Figure 2.1j
Infrastructure Design Review
- Turbine 10

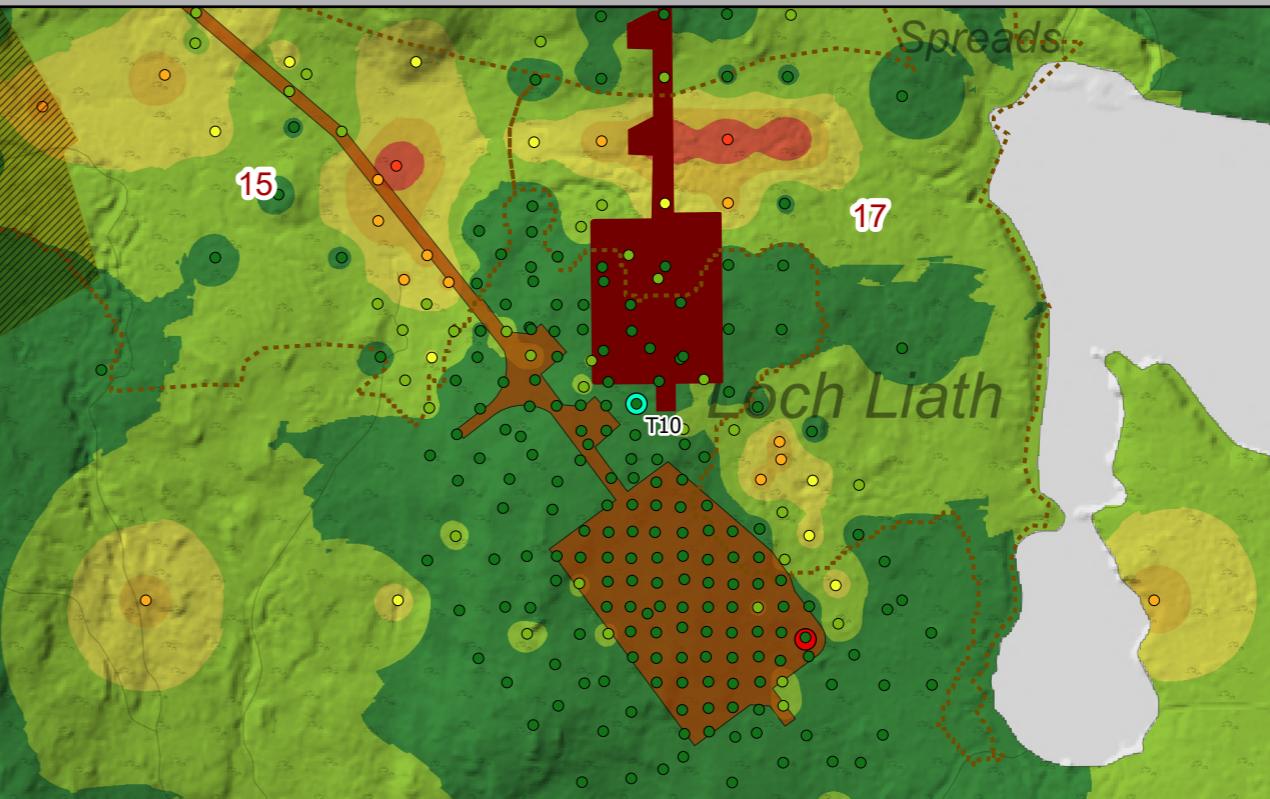
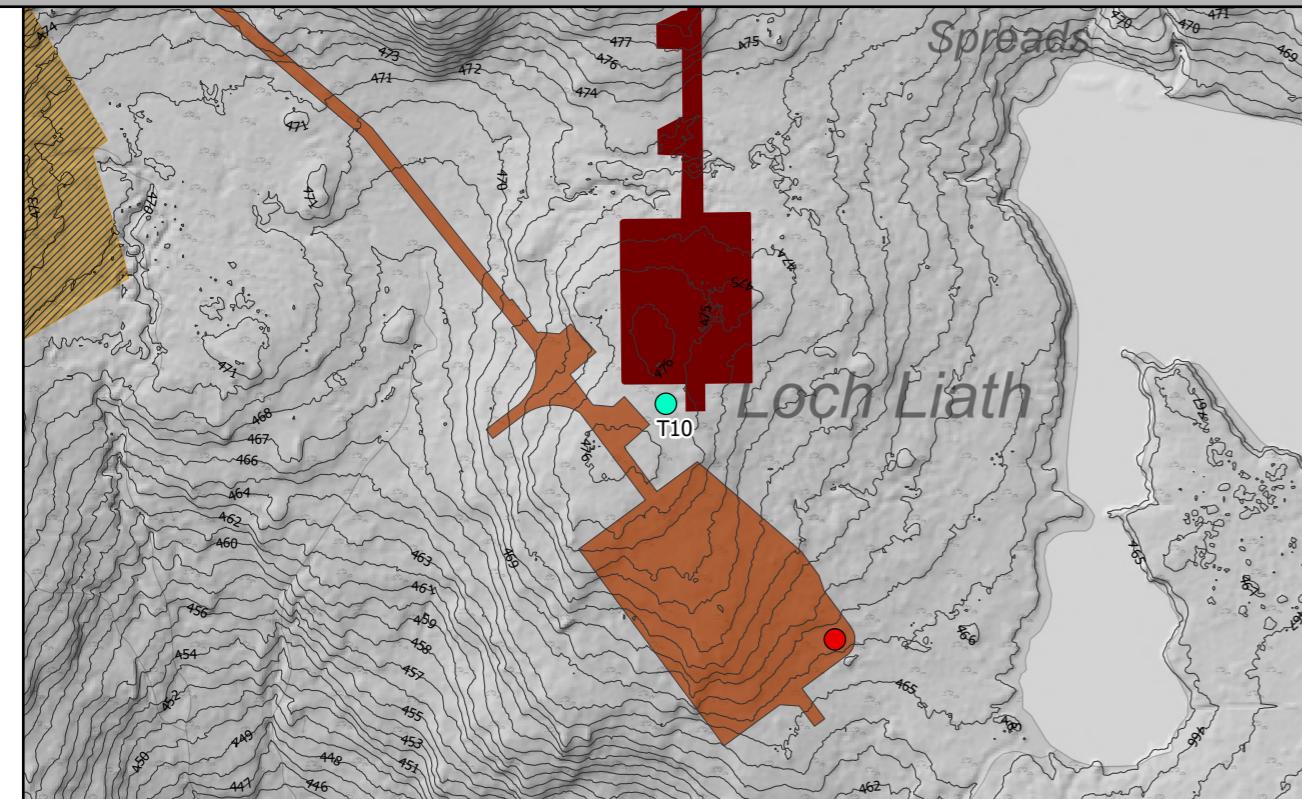
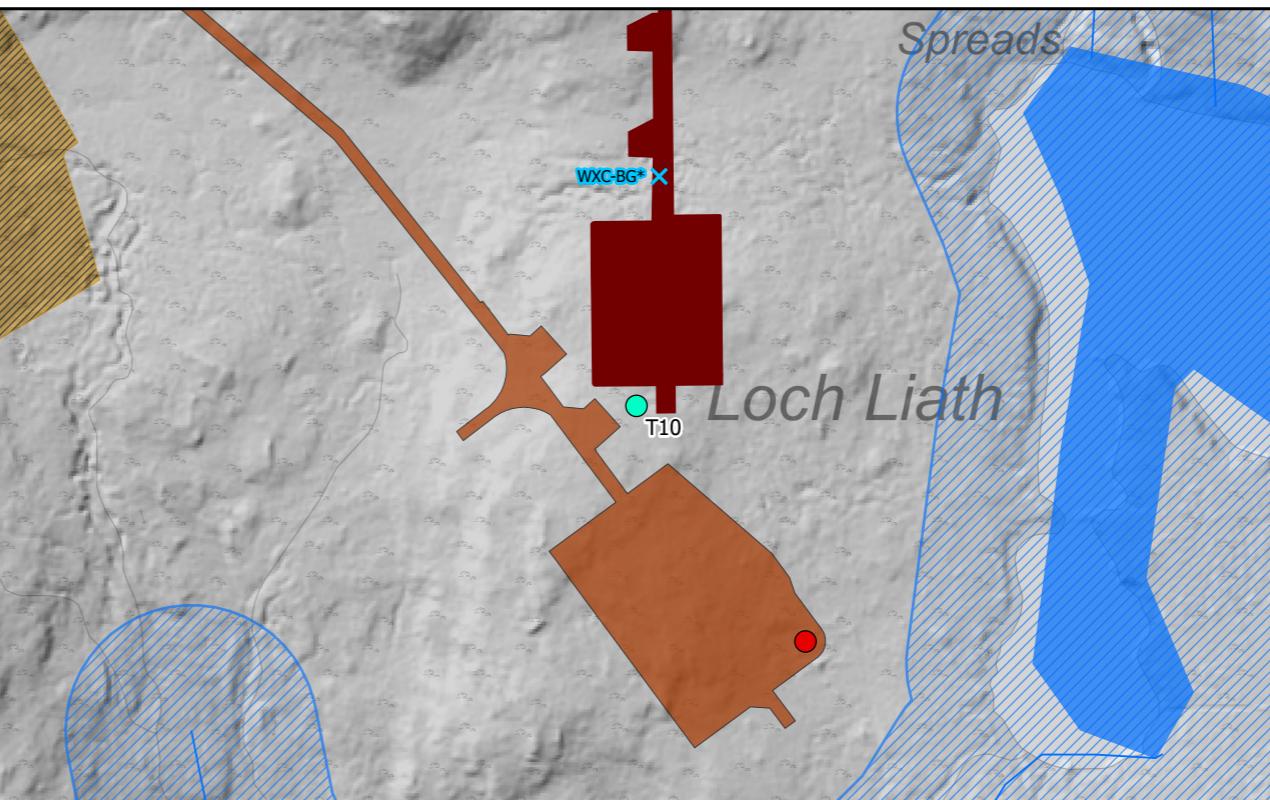
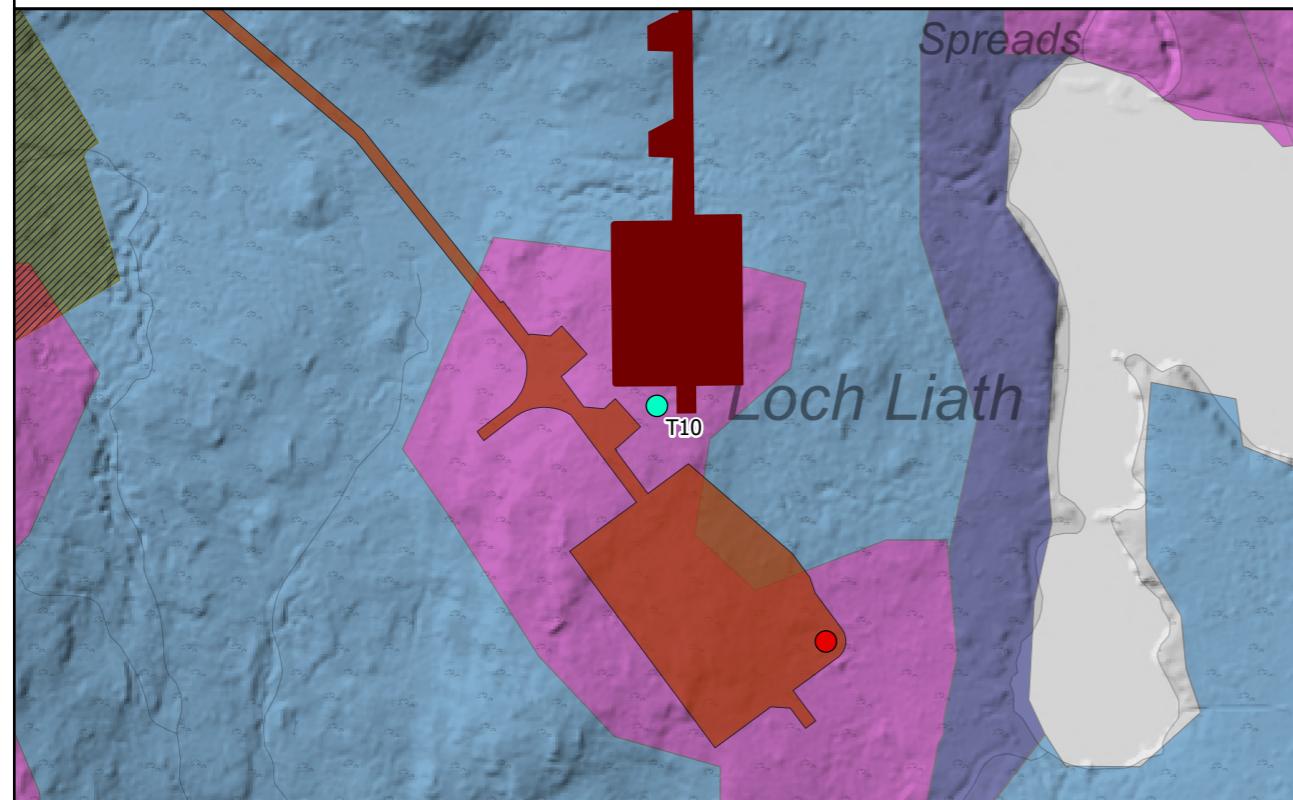
T10: Reason for Moving: This move was necessary because the consented position was too close to the substation platform. The consented position is 1.07 times the tip height of the turbine away from the closest point of the permanent area of the substation platform. To build in safety margins, it is recommended to maintain at least 1.5 times the tip height. Additionally, the consented location placed the turbine too close to neighbouring turbines, necessitating a move south to maintain three rotor diameters.

Engineering: The significant realignment of the access track was required to allow for an acceptable gradient for component access- the Consented layout would have been impossible to accommodate due to high level difference between the main spine road and hardstand. The additional turning has been added to remove any requirement for reverse driving significant distances on steep gradients.

Geology Impacts: The consented hardstand location is situated in areas of shallow, medium, and deep peat. Introducing a larger hardstand would affect more areas of deep peat. The proposed hardstand has been rotated anticlockwise, and the track realigned to shallower slopes, removing the need to construct in deep peat areas.

Ecology Impacts: The proposed layout has a similar impact to the consented infrastructure, occupying areas of Wet Heath (M15c) and Blanket Mire (M17b/M17a/M18a/M19a).

Hydrology Impacts: The proposed location is outside the 50m water buffers.
